HOMOLOGATION AND TECHNICAL SPECIFICATION UPDATE BULLETIN

| HOMOLOGATION | Rotax 125 Max DD2 | HOMOLOGATION NO. | 114H |
| BULLETIN NO. | Rotax 11 DD2 | BULLETIN DATE | 9 December 2016 |
| SUBJECT | Support Plate System for 125 Max DD2 Ignition Coil | | |

Support Plate System for Rotax 125 MAX DD2

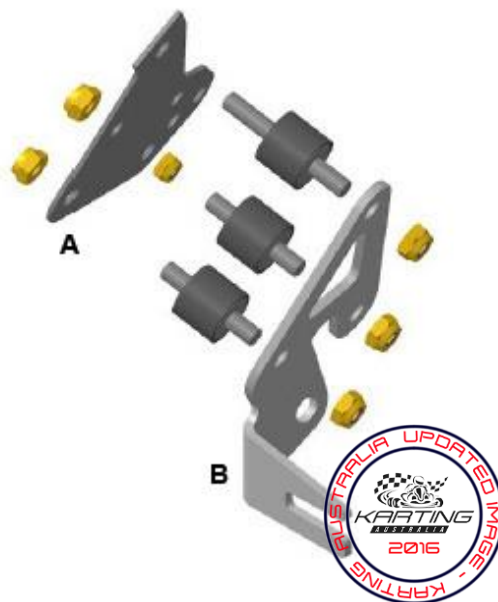
The new support plate system for mounting the ignition coil and magnet valve is a more compact system with less electrical connections at the backside of the engine, and the ECU now located in the battery housing. This system creates less risk of interference from any chassis components.

(A) Mounting Plate (Part No. 651 925)

(B) Retaining Plate (Part No. 651 067)
